**Preliminary Plan 120140070: Williamsburg Village**

**Staff Report Date: 6/10/16**

Request to resubdivide an existing lot (17812 Princess Anne Drive) to create two lots; located at the southwest corner of Princess Anne Drive and Queen Mary Drive, approximately 800 feet west of Georgia Avenue in Olney, MD; 1.59 acres; R-200 zone; Olney Master Plan.

Figure E - Variance Tree #7 Critical Root Zone Impact

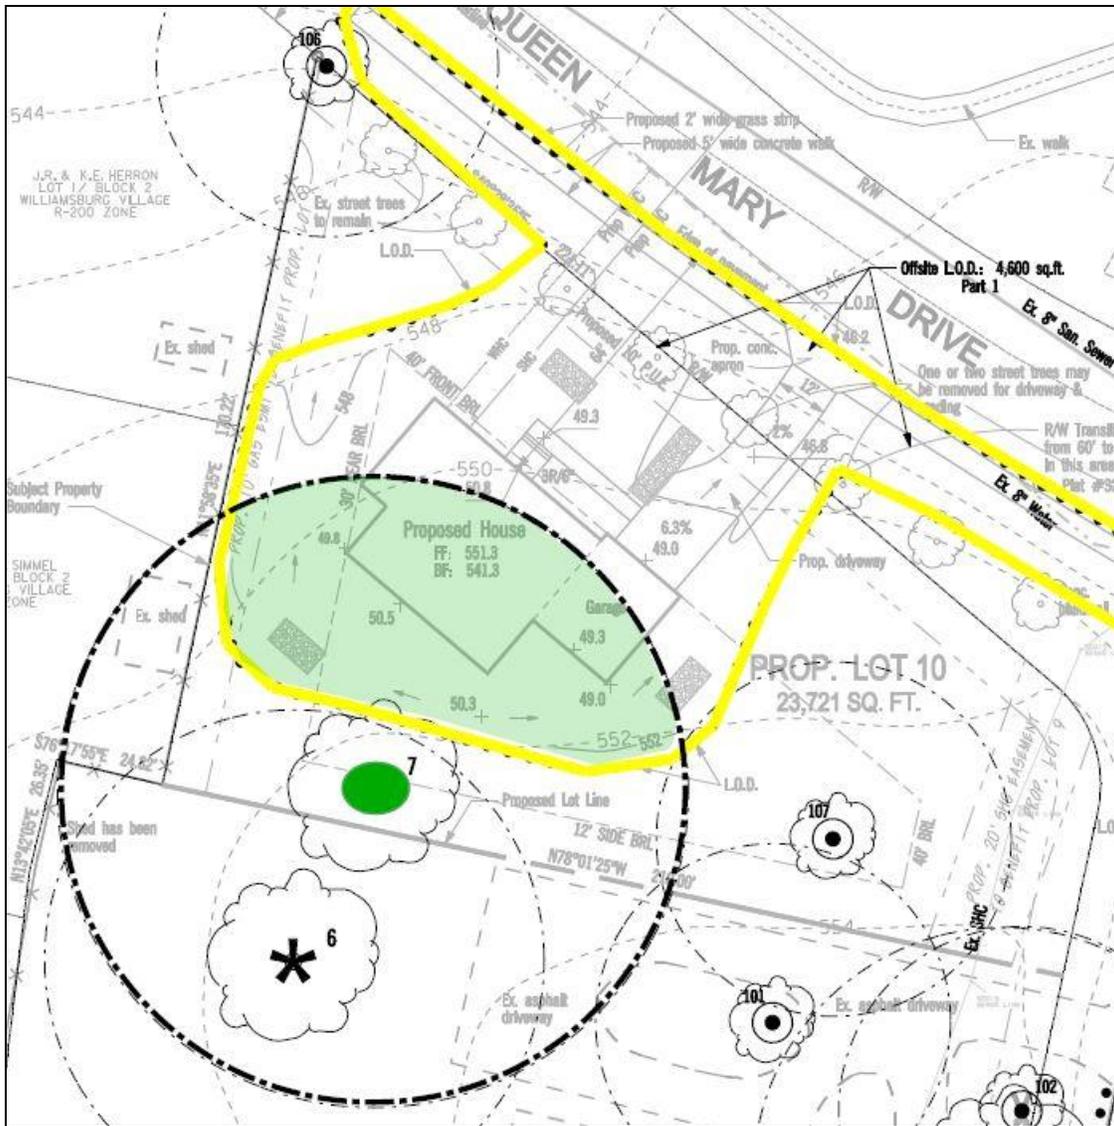
- Tree #7 - 48" DBH American elm, fair condition, 30% CRZ impact for construction of house on Lot 9.

Per Section 22A-21, a variance may only be considered if the Planning Board finds that leaving the Protected Trees in an undisturbed state would result in an unwarranted hardship, denying an applicant reasonable and significant use of a property. The Applicant contends that an unwarranted hardship would be created due to the existing conditions on the Property and the development standards of the zone. The Property does not contain any forest but Protected Trees are located throughout the site. The existing house and driveway are proposed to remain, dictating the configuration of the two lots and the location of the proposed house, in order to meet setbacks and other requirements of the zone. None of the Protected Trees are proposed to be removed by the development and one will be affected, but retained. The tree to be affected is rated in fair condition, but with tree protection measures employed

during construction, this tree is expected to survive. If the variance were not considered, the proposed development on this R-200 zoned Property could not occur. Staff has reviewed this Application and finds that there would be an unwarranted hardship if a variance were not considered.

Variance Recommendation - Staff recommends that the variance be granted without mitigation.
